Access Compliance Report

Public Rights-of-Way

(Curb Ramps)

Intersection ID: 19130	Main Street: BARCLAY_DOWNS_DR	Cross Street: INVERNESS_RD	Location: W
ADA ID: 54D0543561A0	Ramp Type: PerpDiag	Initial Pass/Fail: Fail	Overall Compliance: No
Codes/Mitigation Info/Possible Solution		Field Measurements/Component Compliance	
Severity Score: 13.75

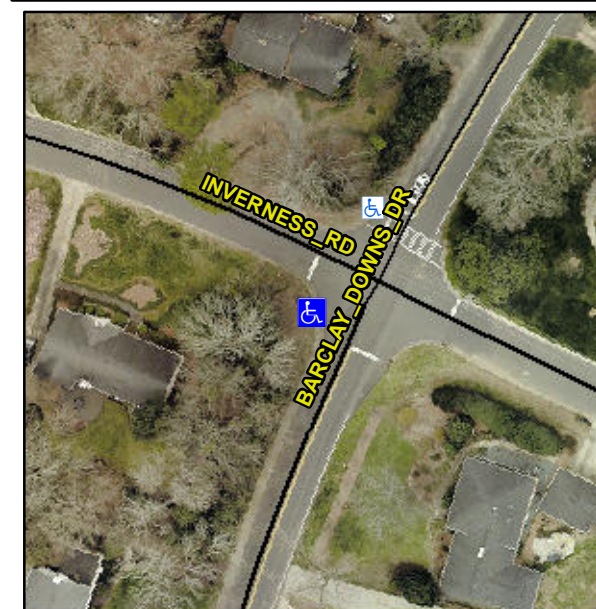
Not Found, R304.2.2, R304.5.3

Compliance	Description	Data	Compliance	Description	Data
N/A	Ramp Length (in)	53.5	No	Ramp Slope (%)	11.9
Yes	Ramp Width (in)	60.0	No	Ramp XSlope (%)	4.3
N/A	Flare Type LT	N/A	N/A	Flare Type RT	N/A
N/A	Flare Slope LT (%)	N/A	N/A	Flare Slope RT (%)	N/A
N/A	Flare Traversable LT?	N/A	N/A	Flare Traversable RT?	N/A
N/A	Landing Length (in)	N/A	N/A	DWS Provided?	N/A
N/A	Landing Width (in)	N/A	N/A	DWS Contrast?	N/A
N/A	Landing Slope (%)	N/A	N/A	DWS Length (in)	N/A
N/A	Landing X Slope (%)	N/A	N/A	DWS Full Width?	N/A
N/A	Landing Curb? (Y/N)	N/A	N/A	DWS Offset (in)	N/A
N/A	Shared Landing?	N/A			
N/A	Gutter Ponding?	N/A	N/A	Gutter Slope (%)	N/A
N/A	Gutter Lip Ht (in)	N/A	N/A	Gutter X Slope (%)	N/A
N/A	Painted X Walk1?	No	N/A	Painted X Walk2?	No
	X Walk 1 Direction	To SE		X Walk 2 Direction	To NE
N/A	X Walk 1 Width (in)	N/A	N/A	X Walk 2 Width (in)	N/A
	X Walk 1 Slope (%)	5.5		X Walk 2 Slope (%)	0.5
	X Walk 1 X Slope (%)	4.2		X Walk 2 X Slope (%)	5.6

Remove & Replace Curb Ramp With Two New Directional Ramps or Equivalent.
